2/02/06	1	CLARIFIED EXPLORATORY PROBING DEPTH
DATE		REVISION
STATE OF HAWAII DEPARTMENT OF TRANSPORTATION HIGHWAYS DIVISION CONSTRUCTION SEQUENCE KUAMOO ROAD RETAINING WALL IN THE VICINITY OF M.P. 1.1 PROJECT NO. 580A-01-02 SCALE: AS NOTED DATE: September 2005 SHEET No. s-6 OF 8 SHEETS

**CONSTRUCTION SEQUENCE**

**KUAMOO ROAD RETAINING WALL**  
**IN THE VICINITY OF M.P. 1J**  
**PROJECT NO. 580A-01-02**

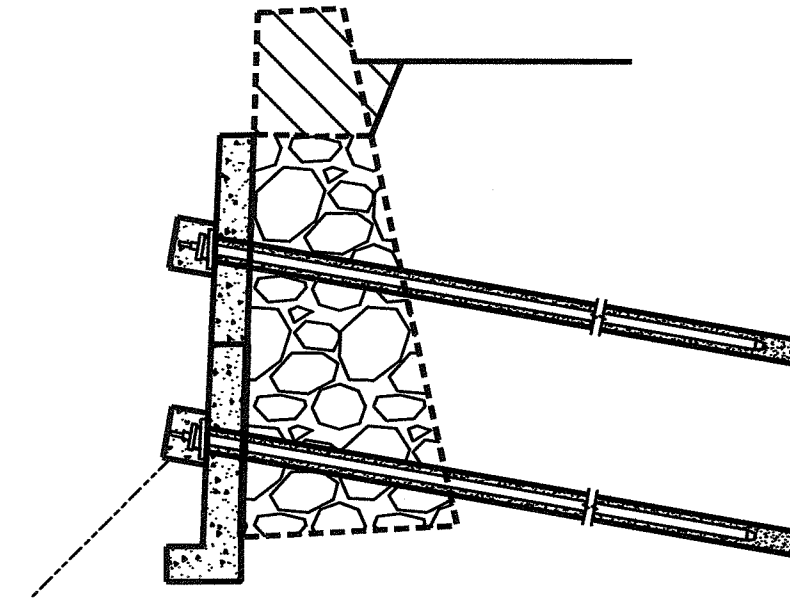
**SEQUENCE CHANGE**  
**Work Done prior to Stressing**  
**of All Tiebacks and Completing**  
**Shotcrete of Bottom Layer**  
**(Phase 3)**

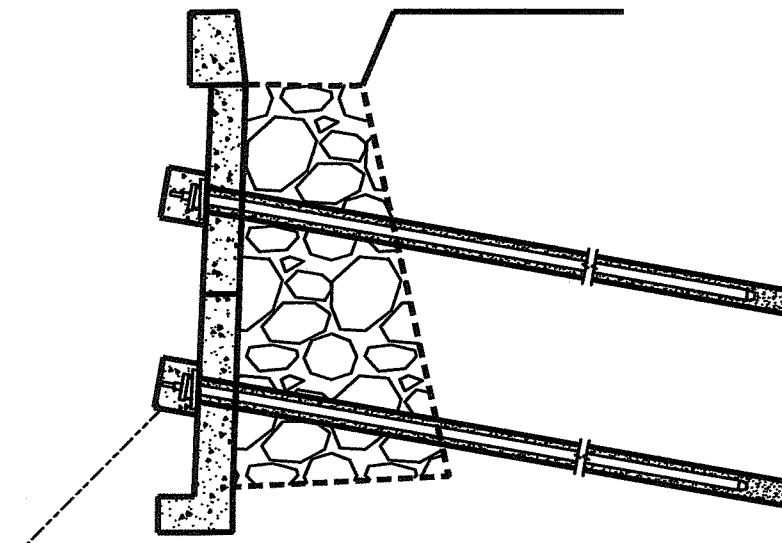
**SEQUENCE CHANGE**  
**Work Done prior to Stressing**  
**of All Tiebacks (Phase 3)**

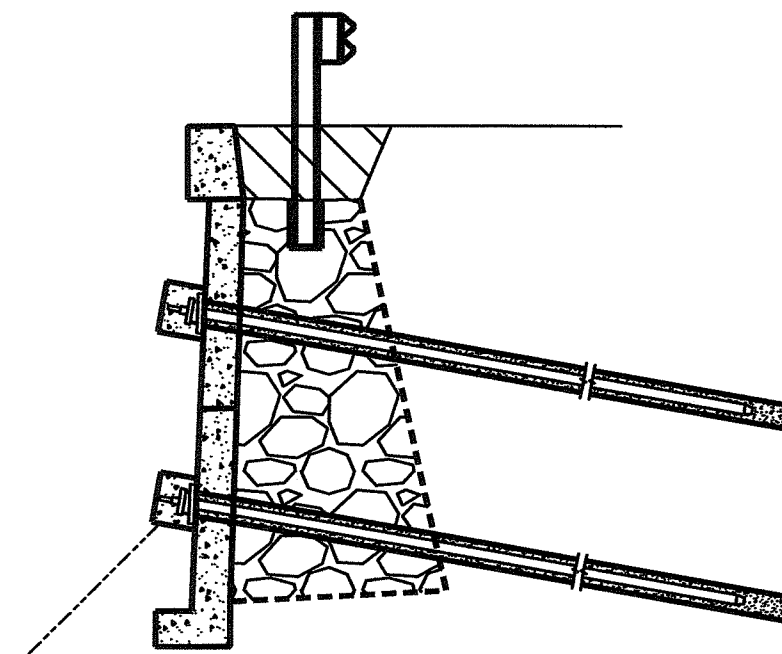
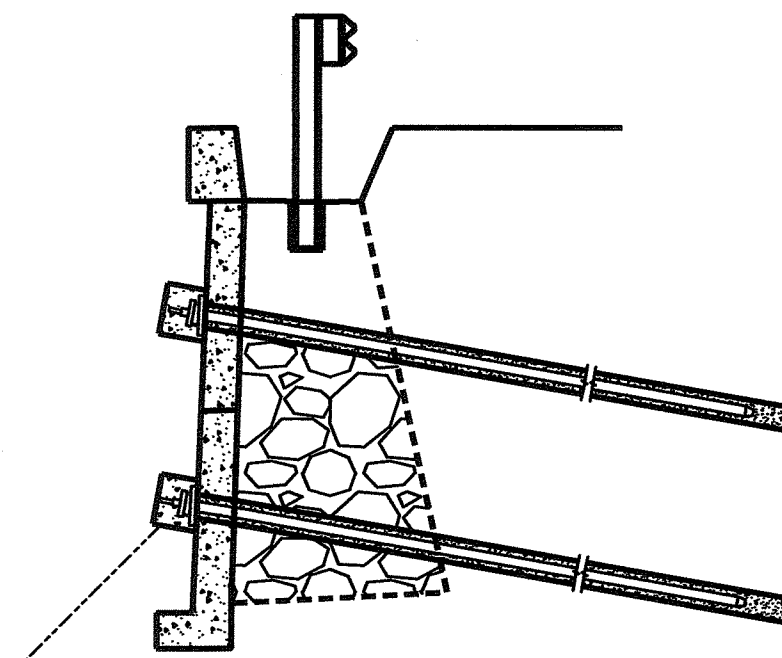
1. ~~Coring~~ top of exposed CRM wall. Hole to be 8" in diameter and not less than 12" deep.
2. Install Guardrail Posts in hole. Posts shall be placed flush to the roadway side of the hole.
3. Fill 8" diameter hole with granular material conforming to ASTM C33, size no. 57.
4. ~~Coring and~~ placing Guardrail Posts may be ongoing with construction of the New Wall Top Beam.

**SEQUENCE CHANGE**  
Work Done prior to Stressing  
of All Tiebacks (Phase 3)
